SUBJECT: Special Management Area (SMA) Major Permit
New Single-Family Dwelling
84-931 Farrington Highway – Mākaha
Tax Map Key 8-4-004: 021

IN THE MATTER OF THE APPLICATION BY YANG GAO AND ZHENGHONG HU FOR A SPECIAL MANAGEMENT AREA (SMA) MAJOR PERMIT	FILE NO. 2024/SMA-70(CK)

FINDINGS OF FACT, CONCLUSIONS OF LAW, AND RECOMMENDATION

EXHIBIT C-1 - OVERALL SITE PLAN
2024/SMA-70

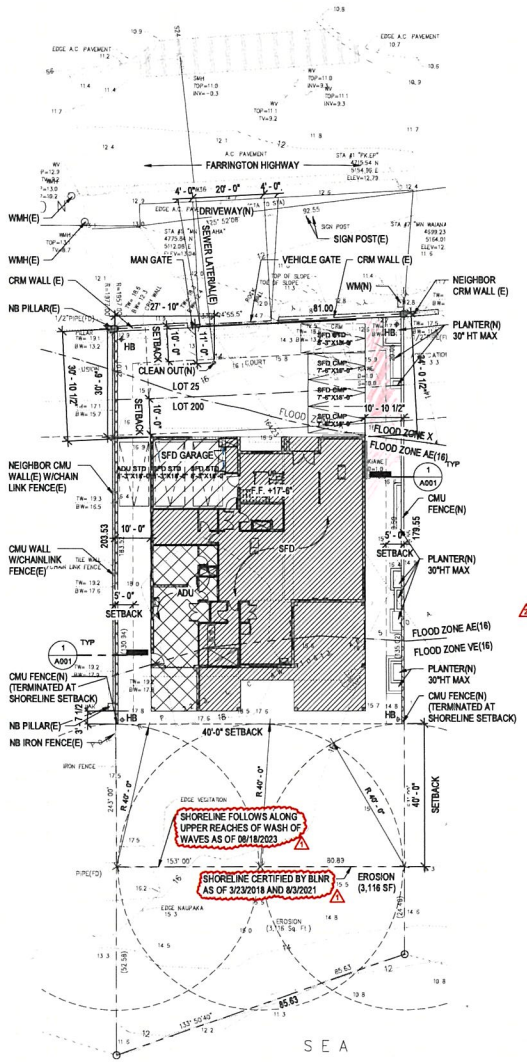
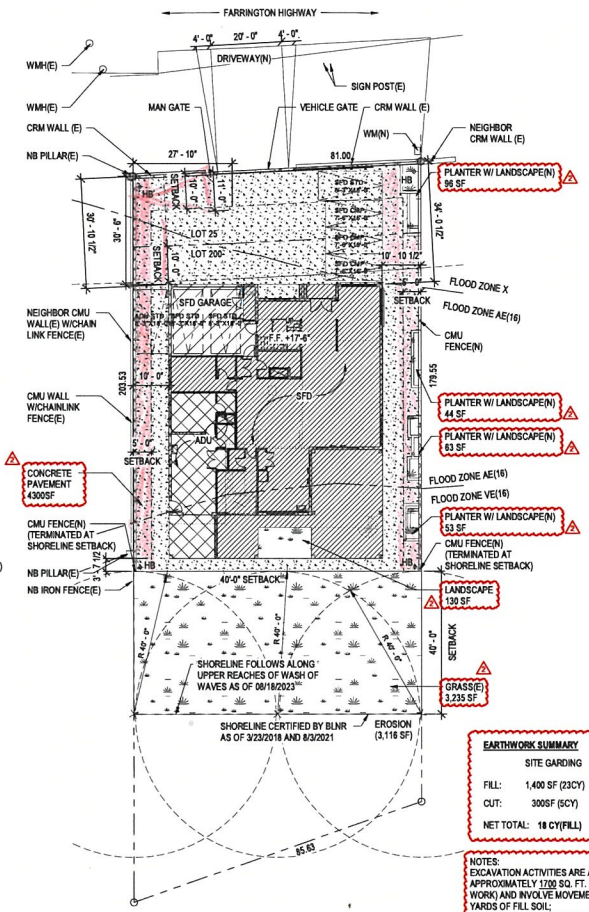
2. The site plan must be revised to show the side yards paved with a pervious material, or the maximum width of the concrete pavement within the side yard must be 30 inches.
